**NOTICE OF A REGULAR MEETING
BONDURANT PLANNING AND ZONING COMMISSION
AUGUST 26, 2021**

TITLE: Return to Table: PZ-210722-18: Considering recommended approval of the Top Farms rezoning from the Agricultural (A-1) District to the Planned Unit Development (R-5) District on property currently owned by Top Farms LLLP north of Park Side Plat 2 and adjacent to Highway 65; and recommended approval of the Future Land Use Map amendment from Single-Family Detached to Multi-Family and Commercial in areas shown on the PUD Conceptual Plan.

TITLE: PZ-210826-20: Considering recommended approval of the SKOL Trucking site plan at 2415 Robinson Avenue NE

1. Top Farms PUD Conceptual Plan 2021-08-23
2. RES. PZ-210722-18 - Top Farms Rezoning, Future Land Use Map Amendment

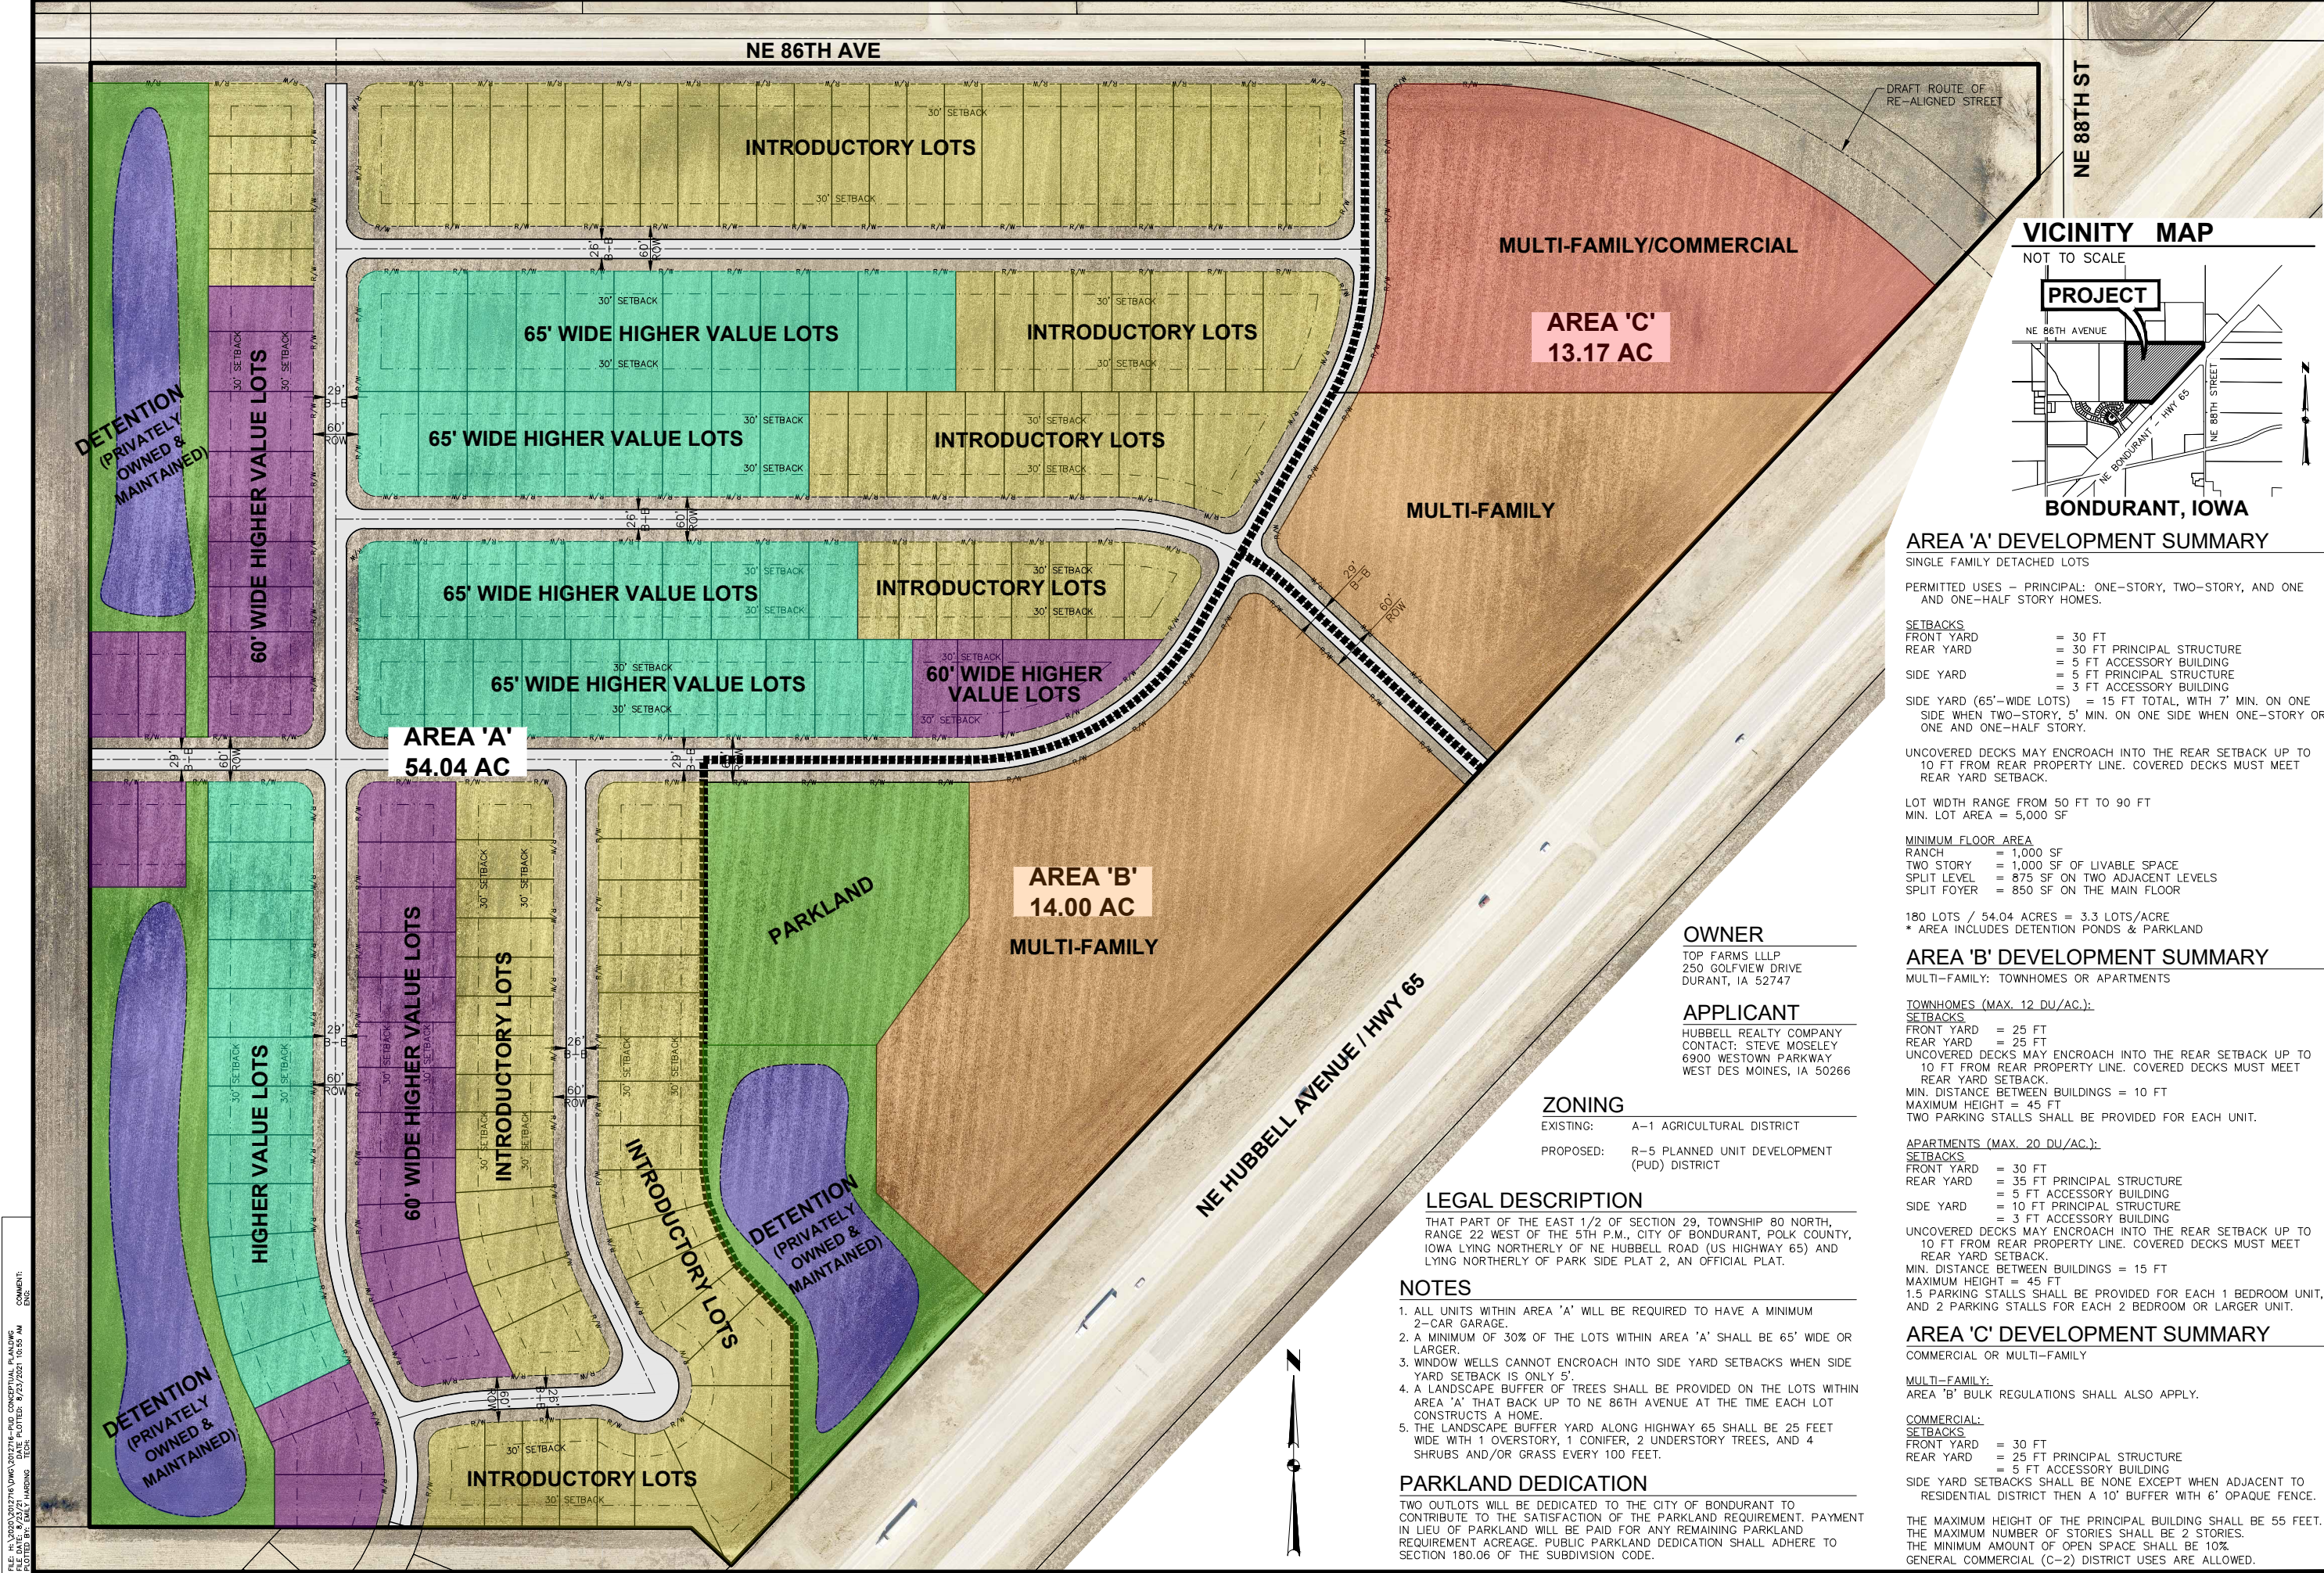
1. At a minimum, 30% of the lots must be 65' or wider. *Item addressed on updated Conceptual Plan.*
2. 30' front yard setbacks to apply to the 65'-wide area. 65'-wide area also subject to the traditional side yard setbacks (15' combined between the 2 side yards, with 7' minimum on one side when 2-story and 5' minimum when 1-story). *Item addressed on updated Conceptual Plan.*

3. Window wells cannot encroach into a required side yard setback when the side yard setback is only 5'. *Item addressed on updated Conceptual Plan.*
4. Uncovered decks may encroach into the required rear yard setback, while covered decks must meet minimum rear yard setback requirements. *Item addressed on updated Conceptual Plan.*

5. Corner lots must have two front yard setback areas. *Item addressed on updated Conceptual Plan (by removing a former note).*
6. Conceptual Plan to be updated to show that detention pond areas will be privately owned and maintained. *Item addressed on updated Conceptual Plan*

7. Conceptual Plan to be updated to also show a front yard setback for those lots having a north property line along NE 86th Avenue. *Item addressed on updated Conceptual*

8. Density should be clarified for Area B by type (and Area C too if developed as multi-family). *Item addressed on updated Conceptual Plan*
9. Allowable height should be clarified for Area B (and Area C too if developed as multi-family). *Item addressed on updated Conceptual Plan*

10. The parking noted in Area B should be updated for consistency with Section 177.09.C of the Zoning Code; this update will help clarify that 1.5 parking spaces must be provided for 1-bedroom units. *Item addressed on updated Conceptual Plan*

11. City staff has maintenance concerns for if two small public park areas are proposed. Developer should consider combining the two public park areas into one larger park in the east park area. *Item addressed on updated Conceptual Plan. The Conceptual Plan shows one public park area consisting of 2.6 acres and having approximately 27% of the park's exterior boundary fronting a public street (Subdivision Code requires a minimum 10% of street frontage). The Conceptual Plan still also notes that payment in lieu of parkland will be paid for any remaining parkland requirement acreage.*
